Product Change Notice (PCN)

Subject: Add Back-End factories, materials for RX/RA LQFP package products

ADD BACK-END FACTORIES, MATERIALS FOR RX/RA LQFP PRODUCTS DIFFERENCE DOCUMENT

IMO-AB-22-0141

10x10mm 64pin LQFP package drawing (Addition)

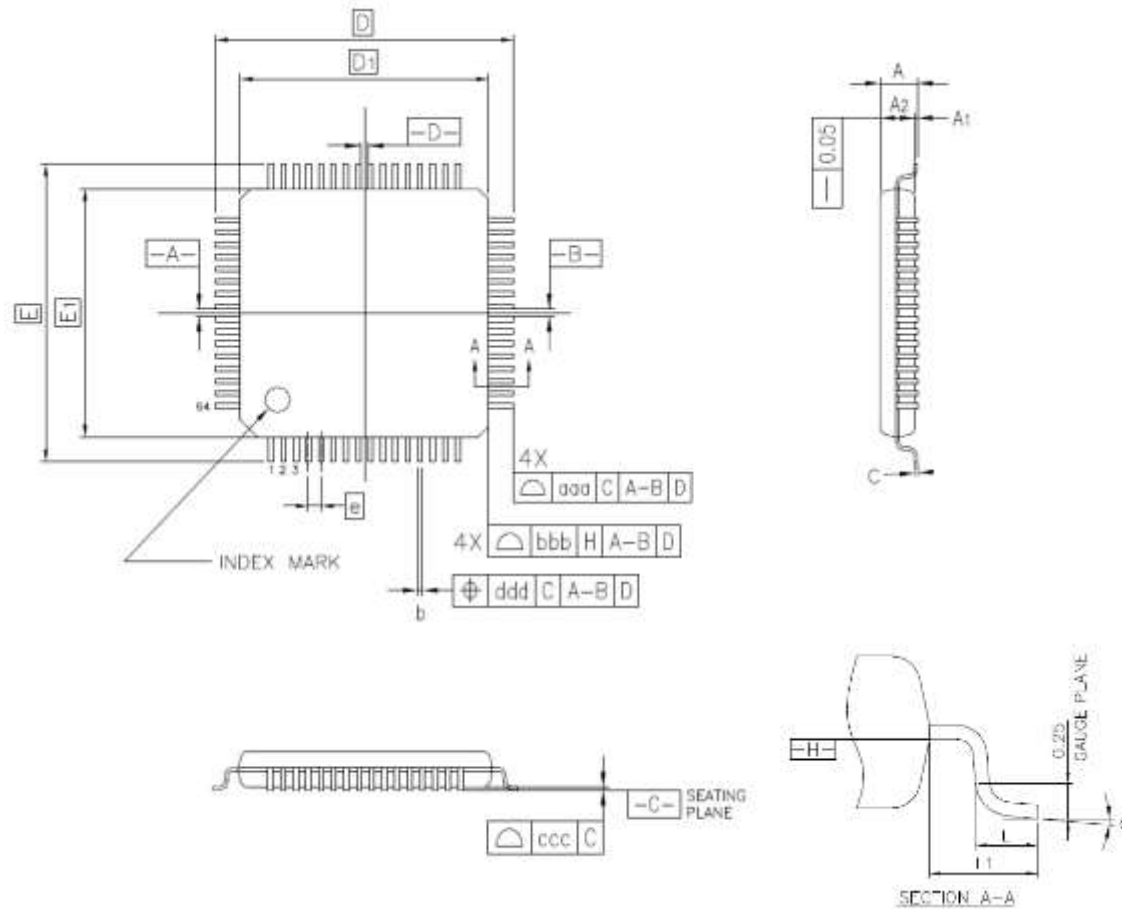
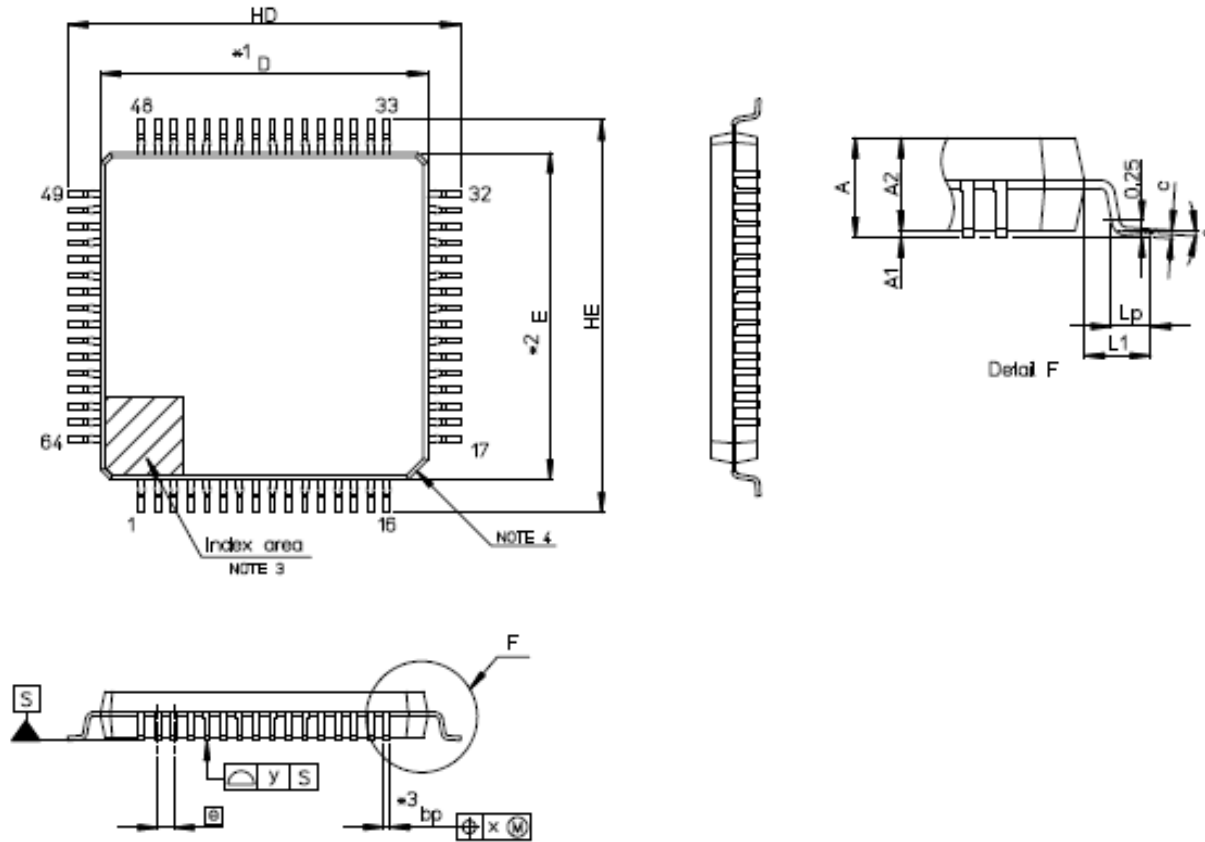
Dimension comparison: 10x10mm 64pin LQFP package

Greatek symbol is the same as the JEDEC standard.

Addition Greatek Symbol	10x10mm 64pin LQFP PLQP0064KL-A			Current RSB Symbol	10x10mm 64pin LQFP PLQP0064KB-C		
	Dimension in Millimeters				Dimension in Millimeters		
	Min	Nom	Max		Min	Nom	Max
A	-	-	1.60	A	-	-	1.70
A1	0.05	-	0.15	A1	0.05	-	0.15
A2	1.35	1.40	1.45	A2	-	1.40	-
D	-	12.00	-	HD	11.80	12.00	12.20
D1	-	10.00	-	D	9.90	10.00	10.10
E	-	12.00	-	HE	11.80	12.00	12.20
E1	-	10.00	-	E	9.90	10.00	10.10
N	-	64	-	-	-	-	-
e	-	0.50	-	e	-	0.50	-
b	0.17	0.22	0.27	bp	0.15	0.20	0.27
c	0.09	-	0.20	c	0.09	-	0.20
θ	0°	3.5°	7°	θ	0°	3.5°	8°
L	0.45	0.60	0.75	Lp	0.45	0.60	0.75
L1	-	1.00	-	L1	-	1.000	-
aaa	-	-	0.20	-	-	-	-
bbb	-	-	0.20	-	-	-	-
ccc	-	-	0.08	y	-	-	0.08
ddd	-	-	0.08	x	-	-	0.08

14x14mm 100pin LQFP package drawing (Addition)

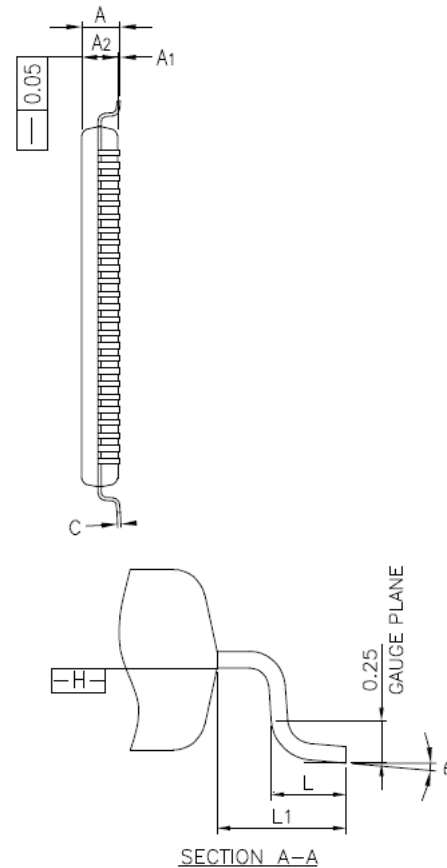
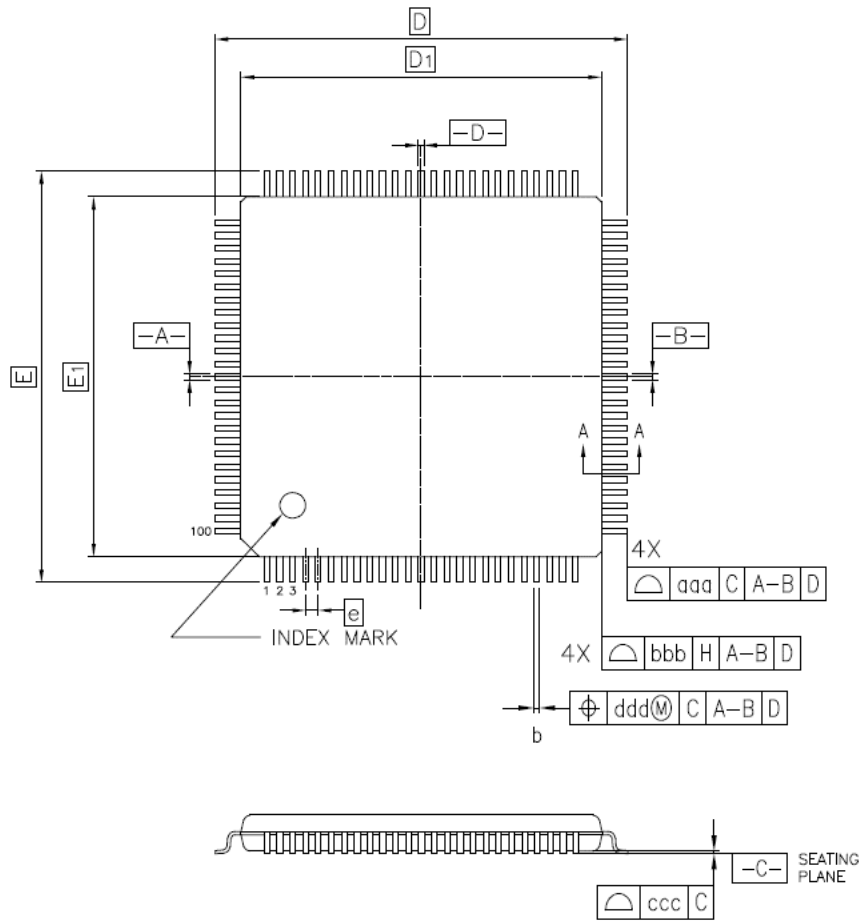
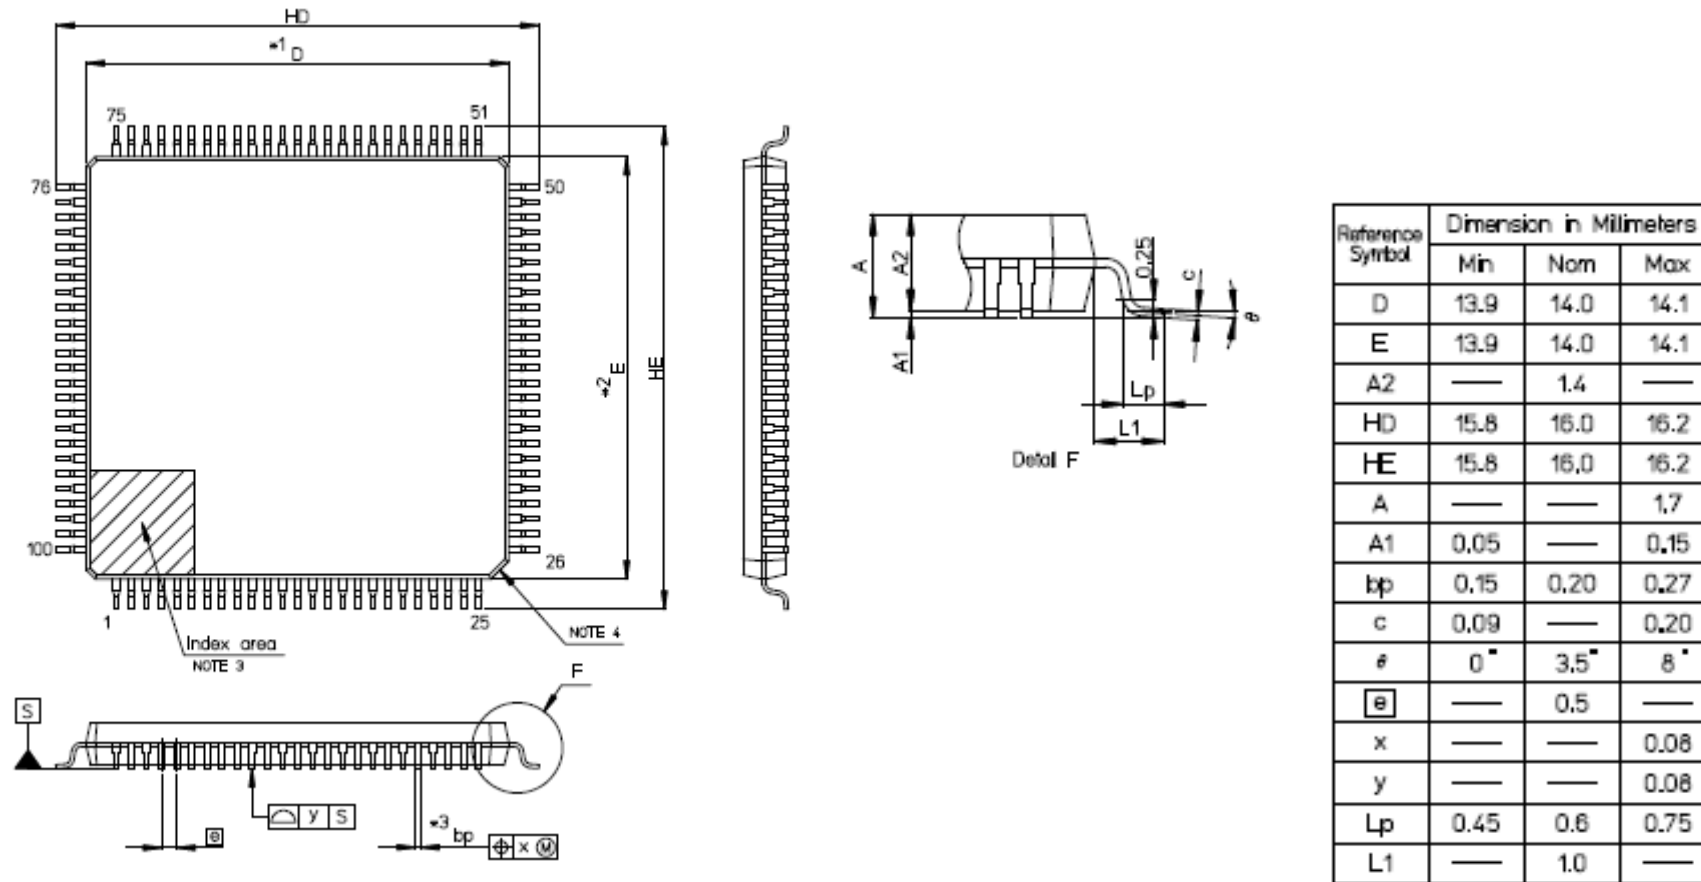
Dimension comparison: 14x14mm 100pin LQFP package

Greatek symbol is the same as the JEDEC standard.

Addition Greatek Symbol	14x14mm 100pin LQFP PLQP0100KP-A			Current RSB Symbol	14x14mm 100pin LQFP PLQP0100KB-B		
	Dimension in Millimeters				Dimension in Millimeters		
	Min	Nom	Max		Min	Nom	Max
A	-	-	1.60	A	-	-	1.70
A1	0.05	-	0.15	A1	0.05	-	0.15
A2	1.35	1.40	1.45	A2	-	1.40	-
D	-	16.00	-	HD	15.80	16.00	16.20
D1	-	14.00	-	D	13.90	14.00	14.10
E	-	16.00	-	HE	15.80	16.00	16.20
E1	-	14.00	-	E	13.90	14.00	14.10
N	-	100	-	-	-	-	-
e	-	0.50	-	e	-	0.50	-
b	0.17	0.22	0.27	bp	0.15	0.20	0.27
c	0.09	-	0.20	c	0.09	-	0.20
θ	0°	3.5°	7°	θ	0°	3.5°	8°
L	0.45	0.60	0.75	Lp	0.45	0.60	0.75
L1	-	1.00	-	L1	-	1.000	-
aaa	-	-	0.20	-	-	-	-
bbb	-	-	0.20	-	-	-	-
ccc	-	-	0.08	y	-	-	0.08
ddd	-	-	0.08	x	-	-	0.08

Appearance: 14x14mm 100pin LQFP package

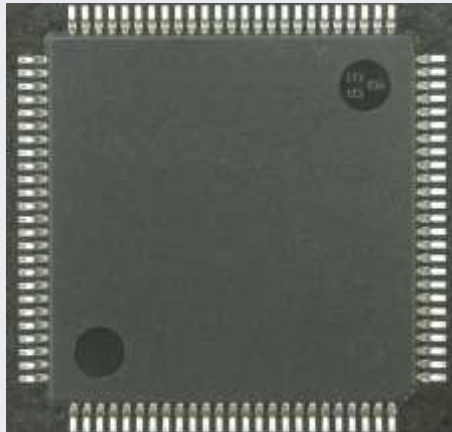
Package surface	Package back	Worked Leads shape
Current			
Addition

* There is no WS notation in the actual product
